Item ID: D206-642-341BL

Item Name: Replacement Skidtube (Fits LH or RH)

DRAWING NO. D2650	TITLE 206/407 SKIDTUBE ASSEMBLIES	REV. F	DART AEROSPACE LTD ENGINEERING ORDER		D.E.O. NO. D2650-F-1	SHEET NO. SHEET 1 OF 1	SCALE NTS
DRAWN <i>[Signature]</i>	CHECKED A.P.	MFG. APPR. <i>[Signature]</i>	APPROVED <i>[Signature]</i>		DE APPR. <i>[Signature]</i>		
DATE 12.10.12	DATE 12.10.22	DATE 12.10.22	DATE 12.10.22		DATE 12.10.22

CHANGE C'BORED WELDED CROSSBOLT SPACERS TO SWAGED SPACERS

DETAIL B

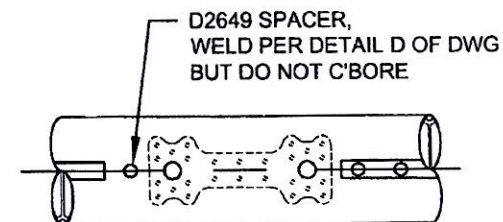
ADD DETAIL G BELOW, WHICH IS THE SAME SECTION VIEW AS DETAIL D OF DWG.
C'BORED HOLES ARE **NOW SWAGED** PER DETAIL G BELOW. FOR THE Ø0.375 HOLE THAT IS NOT C'BORED, WELD PER DETAIL D OF DWG (SEE AMENDED DETAIL B FOR REFERENCE).

AMENDMENT TO DETAIL B
NOT TO SCALE

DETAIL G

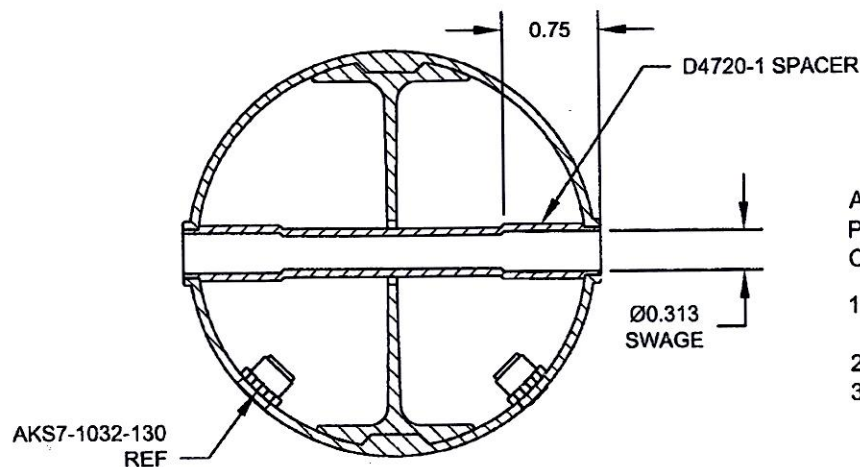
FOR Ø0.375 HOLES ONLY
FOR HOLES THAT ARE CURRENTLY C'BORED ONLY
NOT TO SCALE

AFTER DRILLING AND BENDING ASSEMBLY
PERFORM THE FOLLOWING FOR Ø0.375 HOLES THAT ARE
CURRENTLY C'BORED:

1. INSERT D4720-1 SPACER, 16 PL (-1) OR 17 PL (-3)
OR 19 PL (-5) OR 23 PL (-7)
2. SWAGE TO Ø0.313 X 0.75 DP PER QSI 002
3. TRIM / GRIND FLUSH PER QSI 002
